APPLICATION FOR PERMISSION
UNDER SECTION 16 OF
THE TOWN PLANNING ORDINANCE
(CAP.131)

For Official Use Only 請勿填寫此欄	Application No. 申請編號	A176-KTS/923
	Date Received 收到日期	27 APR 2022

(a) Application number to which the permission relates 與許可有關的申請編號	A/ YL-KTS, 819
(b) Date of approval 獲批給許可的日期	3-5-2019 (DD 日/MM 月/YYYY 年)
(c) Date of expiry 許可屆滿日期	24-6-2022 (DD 日/MM 月/YYYY 年)

(d) Approved use/development 已批給許可的用途/發展	臨時存放及停泊私家車 (為期3年)
(e) Approval conditions 附帶條件	<p><input type="checkbox"/> The permission does not have any approval condition 許可並沒有任何附帶條件</p> <p><input checked="" type="checkbox"/> Applicant has complied with all the approval conditions 申請人已履行全部附帶條件</p> <p><input type="checkbox"/> Applicant has not yet complied with the following approval condition(s): 申請人仍未履行下列附帶條件：</p> <p>.....</p> <p>.....</p> <p>Reason(s) for non-compliance: 仍未履行的原因：</p> <p>.....</p> <p>.....</p> <p>(Please use separate sheets if the space above is insufficient) (如以上空間不足，請另頁說明)</p>

園境設計圖

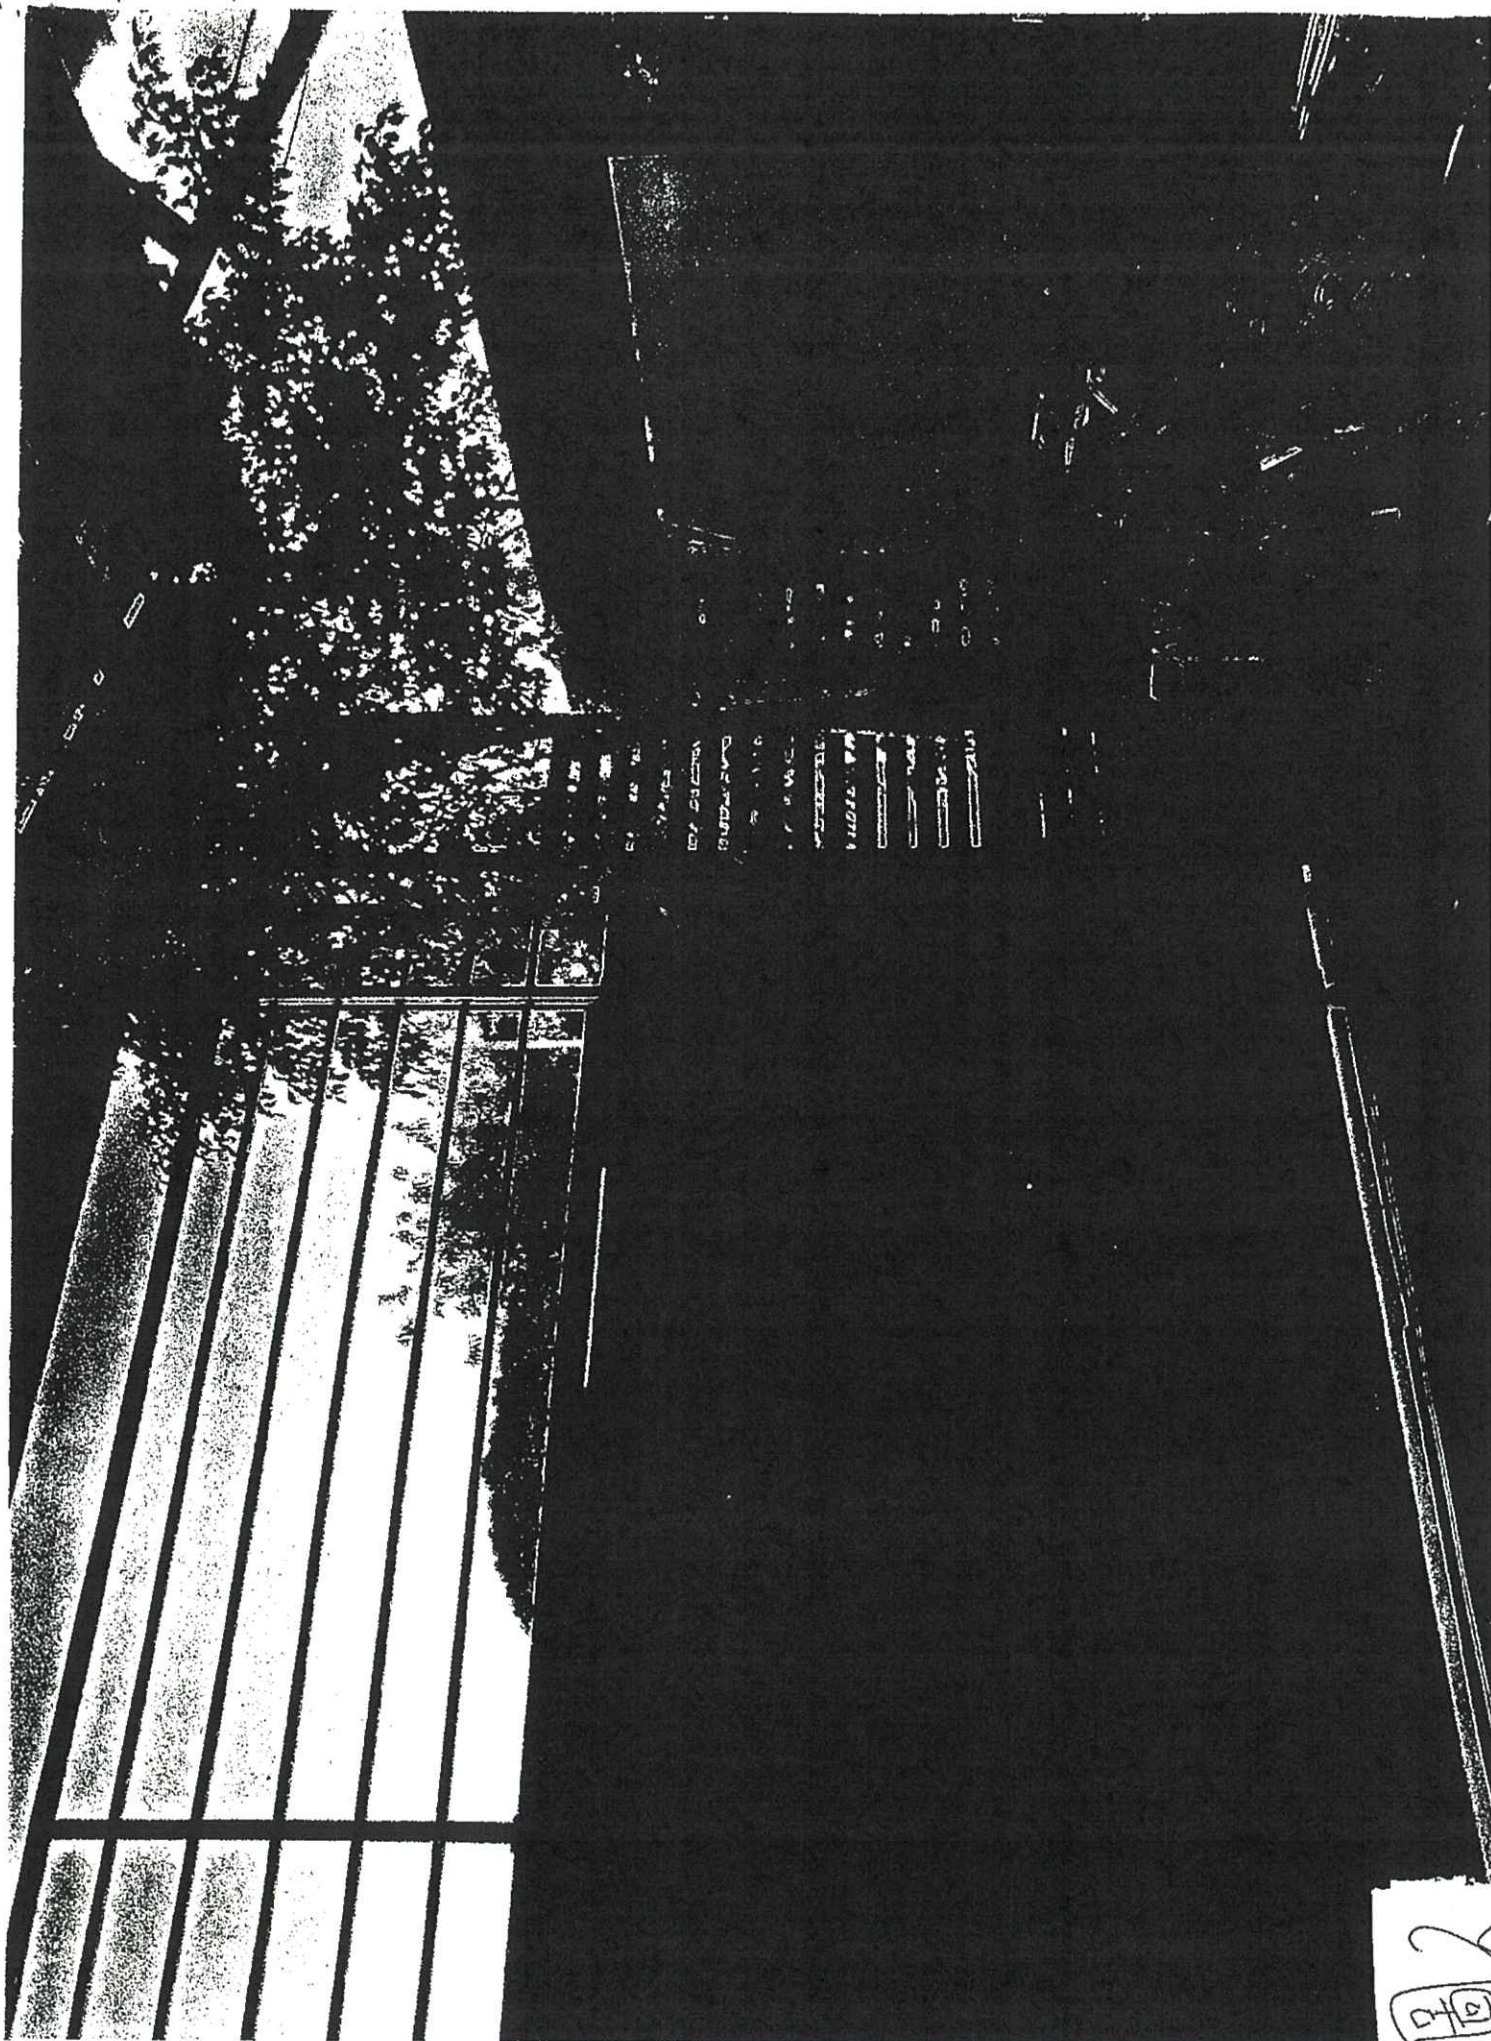
回應環保署的意見:

基於申請地點曾經獲批准運作已十多年,現根據原有申請編號 A/YL-KTS/819 美化環境設施,所有參數沒有改變,由於鄰近貨櫃車場已種有 13 棵樹非常高大,而申請地點亦已種了兩棵細葉蓉樹在門口左右兩邊(圖 1,2),每天澆水保養良好.

⊕ 現有樹木 13 棵

⊗ 加種 2 棵細葉榕樹 3 米高 (圖 1, 2.)

擺放車平面圖

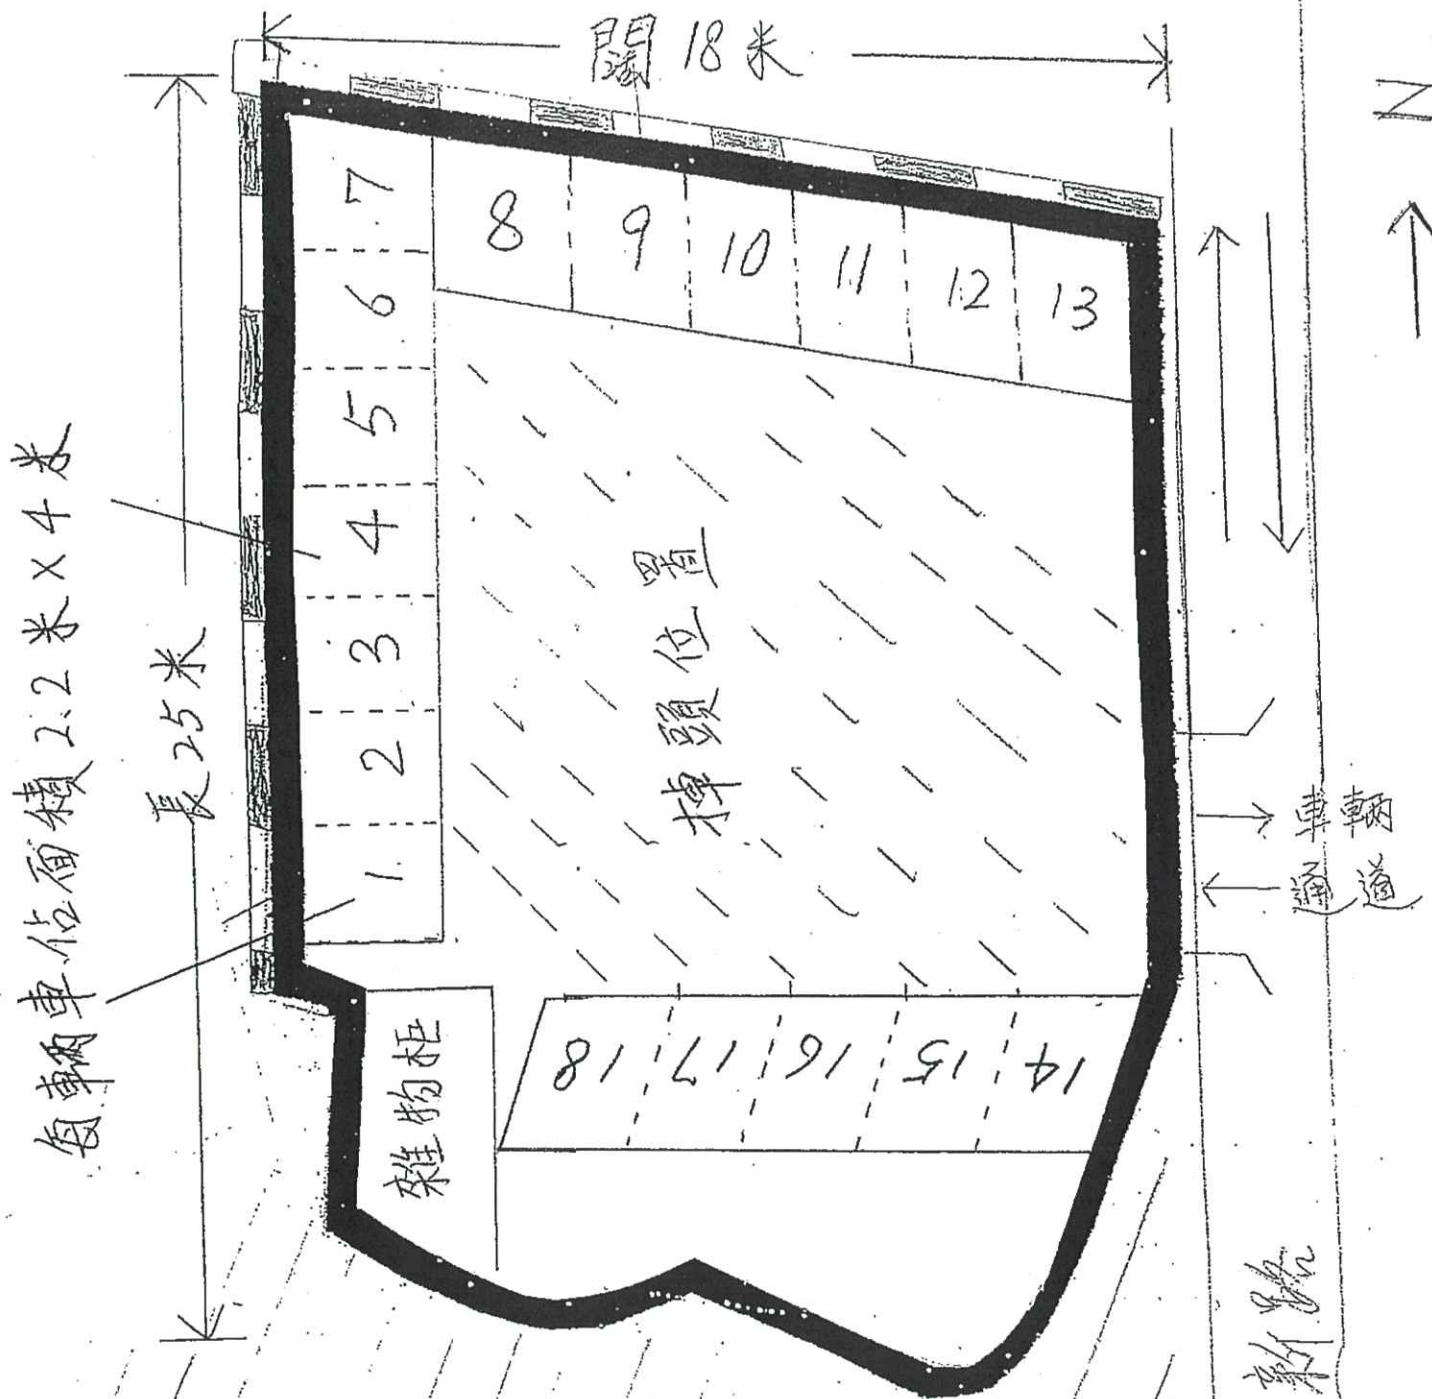
回覆運輸署四點意見:

- a) 申請地點面積 450 平方米可足夠停放 18 架車輛，可以在場內掉頭，不需要在路口倒車，請參閱圖 1.
- b) 在申請地點場內所有車輛都是本人所有，長期存放，很少移動，只是本人每天回場地巡視出入一次，所以不會做成附近居民影響.
- c) 申請地點出入口非常寬闊，左右兩面都沒有建築物遮蔽，視野良好，出入不會做成危險或意外，請參閱圖 2 及圖 3.
- d) 知道.

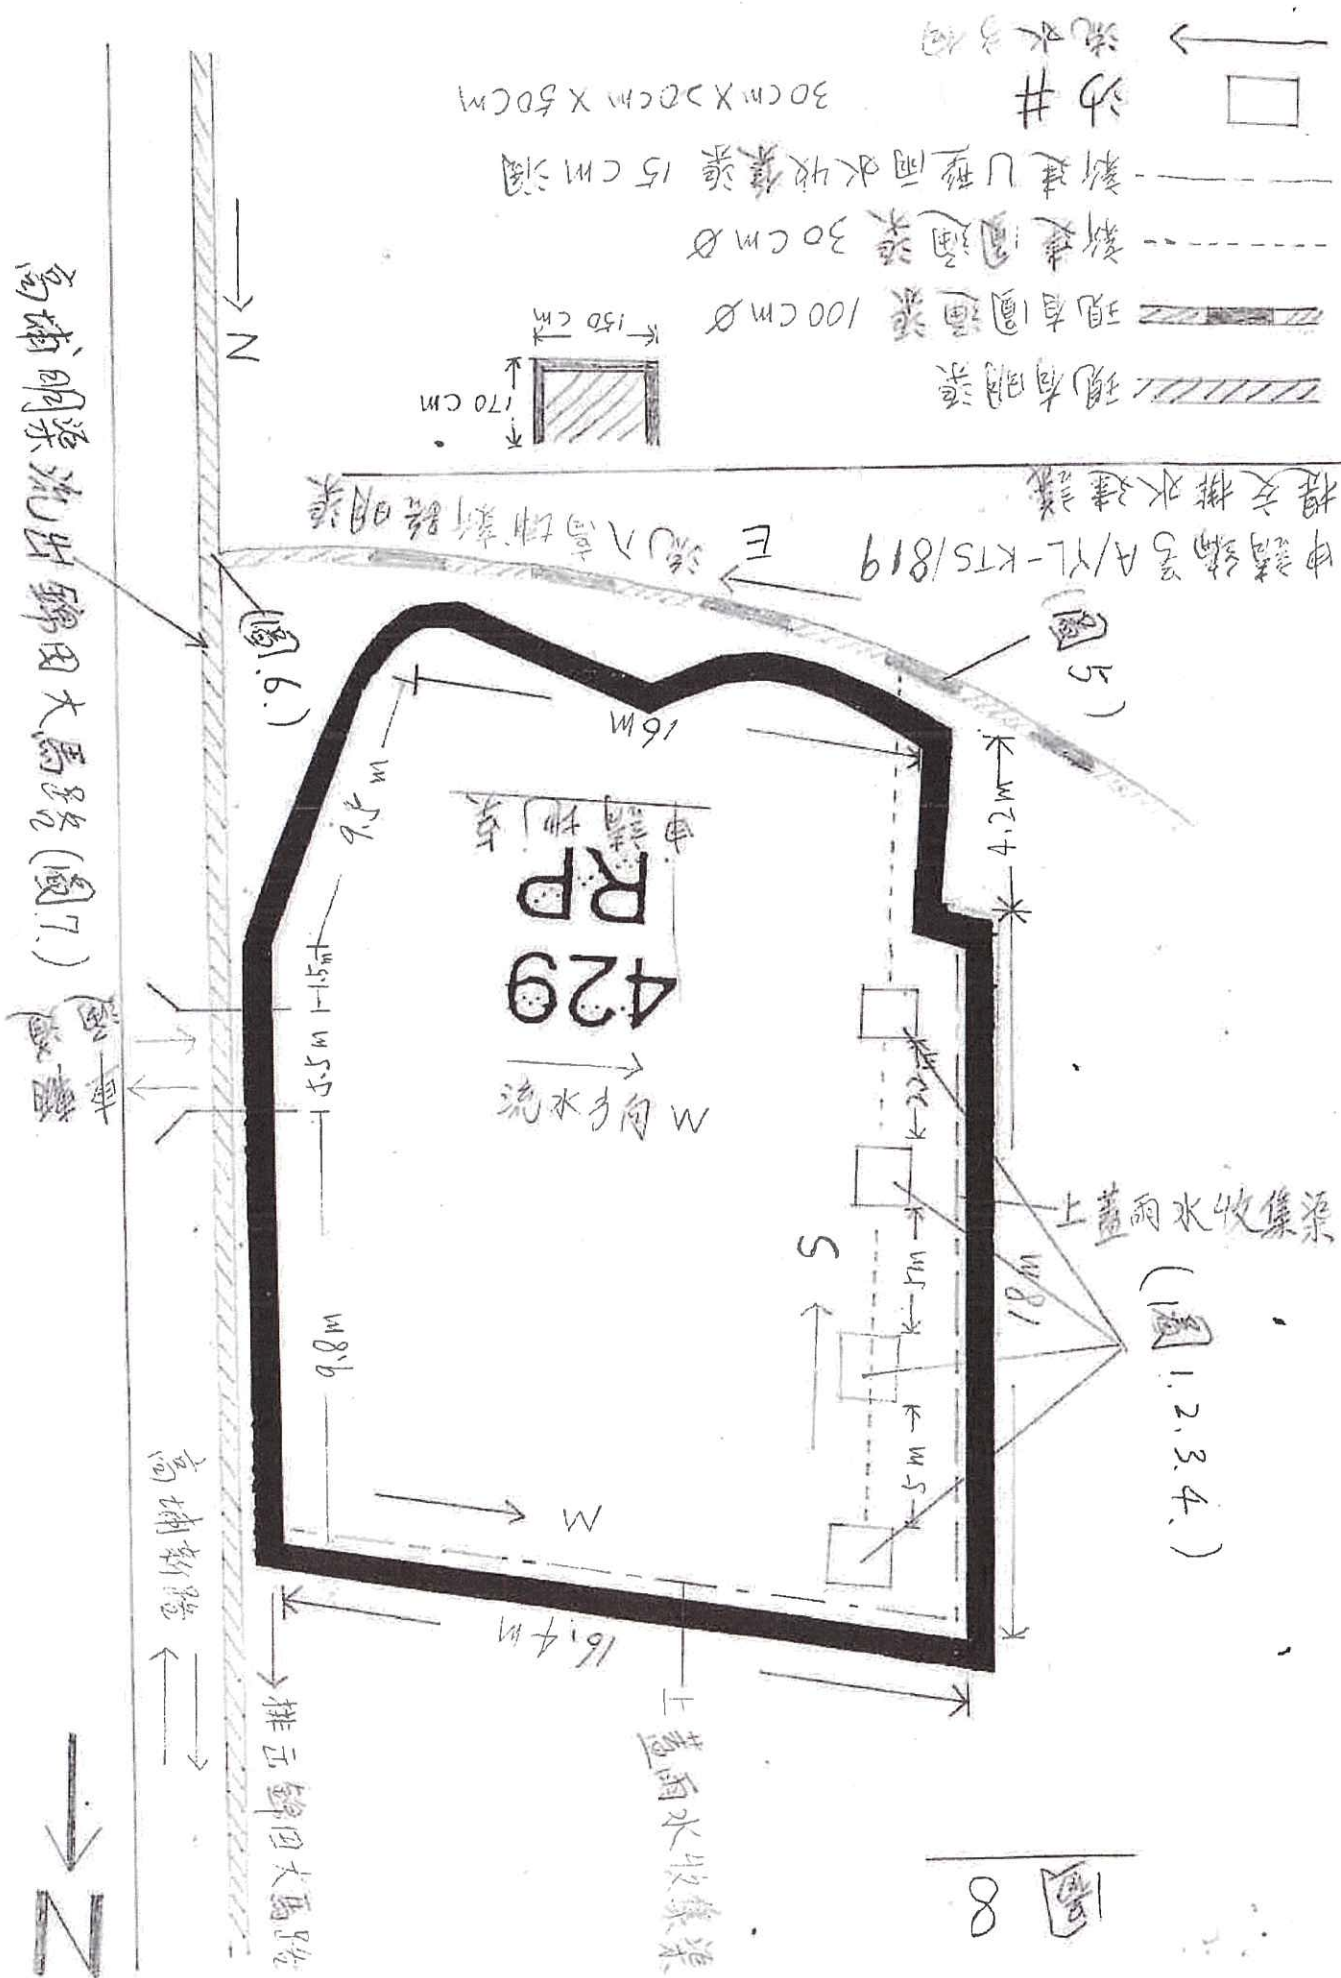
希望能符合渠務署的要求,敬請查閱. 謝謝!

現有排水設施基於申請地點曾經獲批准運作已十多年,現根據原有申請編號 A/YL-KTS/819 渠務設施,沒有改變,保養良好,每日清理,保持暢通,現附上圖示八張,以作參考,將雨水從雨水渠收集後流向沙井(圖 1,2,3,4)再流到原有山澗渠(圖 5,6)後排出高埔新路明渠(圖 7)後排出錦田大馬路.

滅火桶擺放位置圖

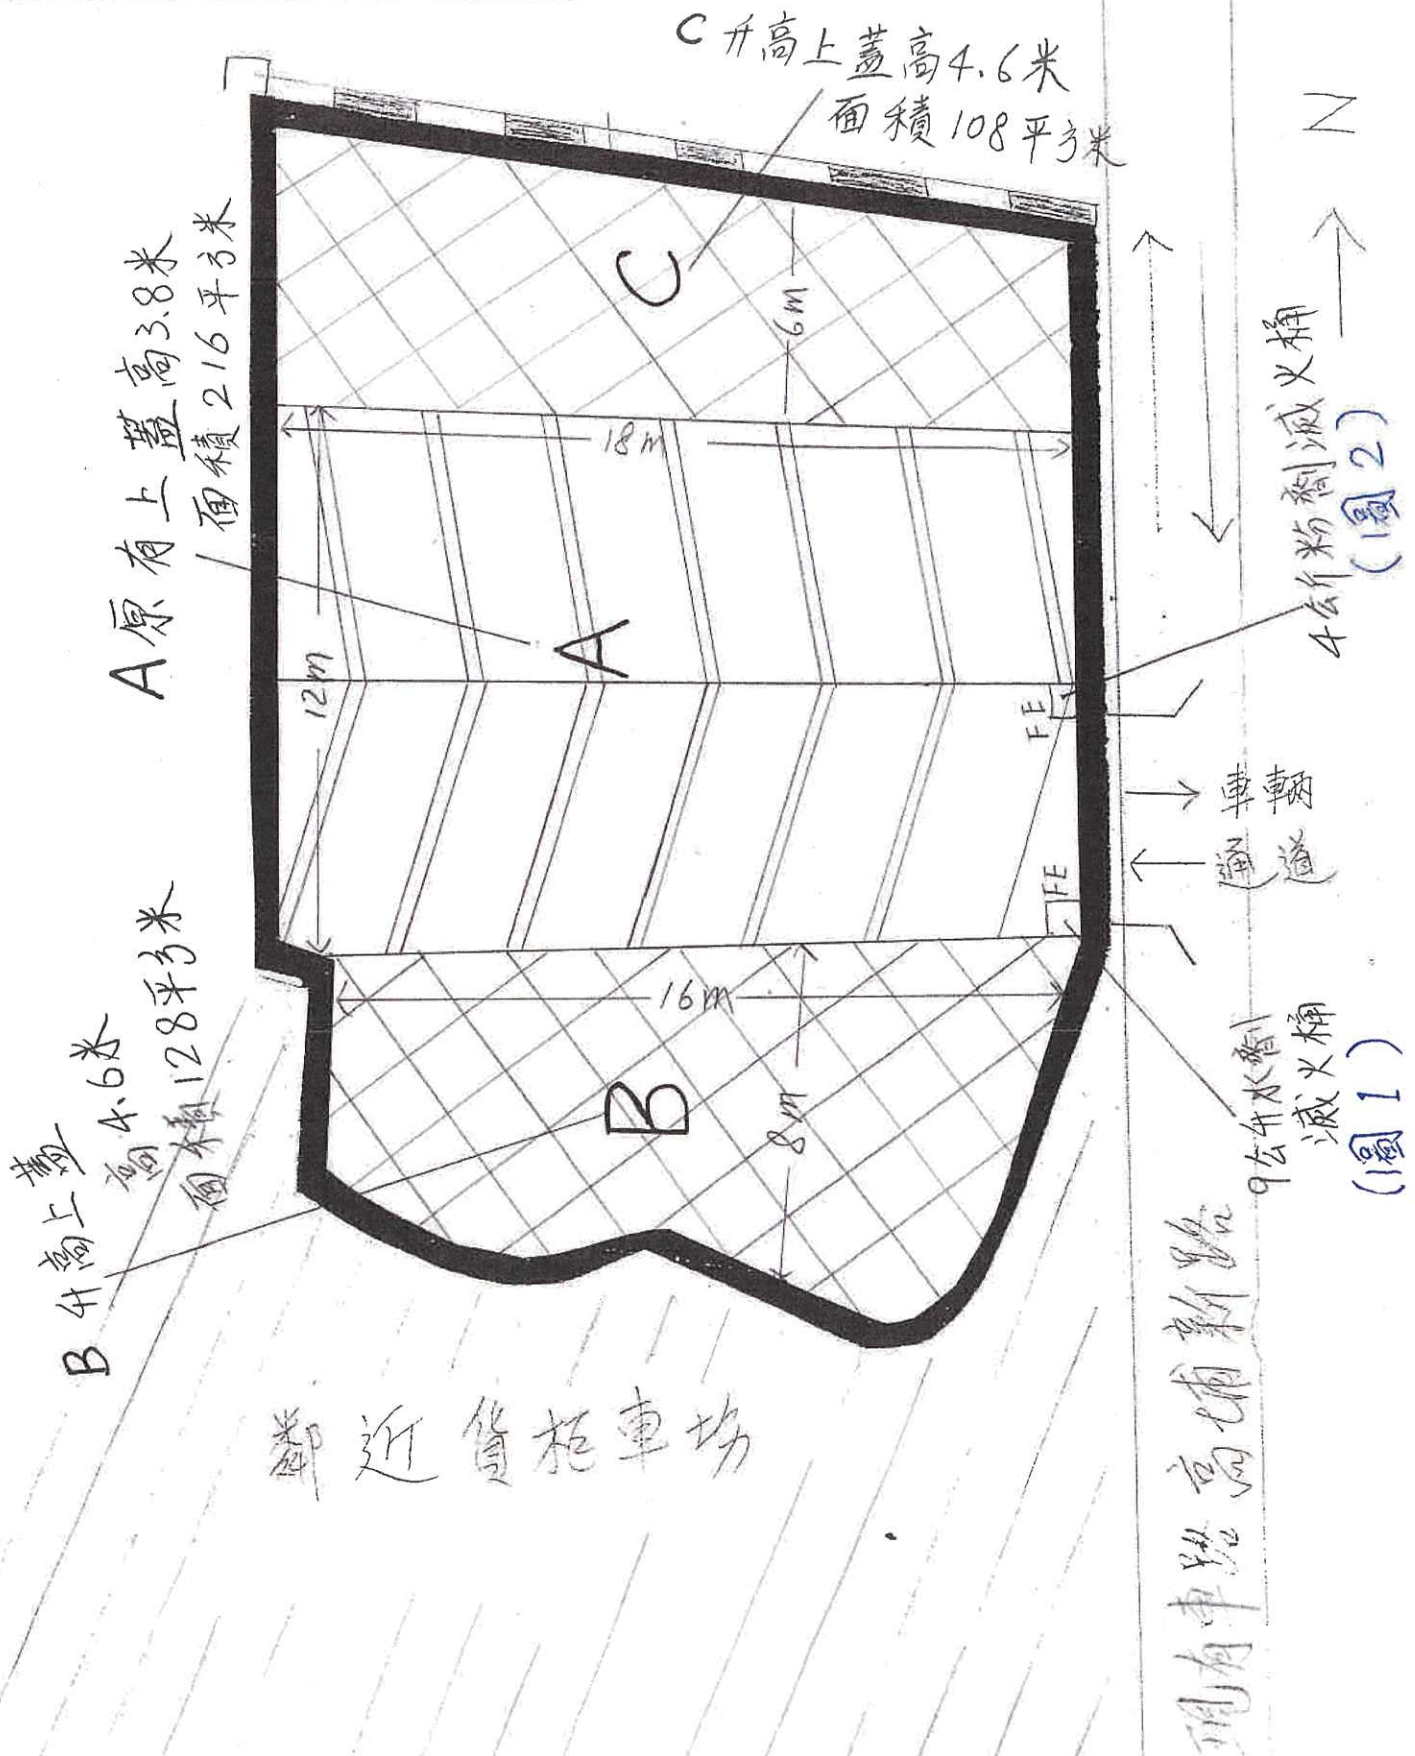
消防裝置建議

申請地點曾經獲批准運作已十多年,現根據原有申請編號 A/YL-KTS/819 消防設施,沒有改變,由於申請地點面積 450 平方米,上蓋面積分為 A,B,C 三部份. 附上繪圖一張, A 部份上蓋面積 216 平方米,高度 3.8 米, B 部份面積 128 平方米,高度 4.6 米, C 部份面積 108 平方米,高度 4.6 米. A,B,C 三部份上蓋全部四面通風.

現建議設置原有兩個滅火桶擺放在門口左右兩邊(圖 1,2) 1 個 4 公斤粉劑及 1 個 9 公升水劑, 另附上滅火桶擺放位置圖 1 張.
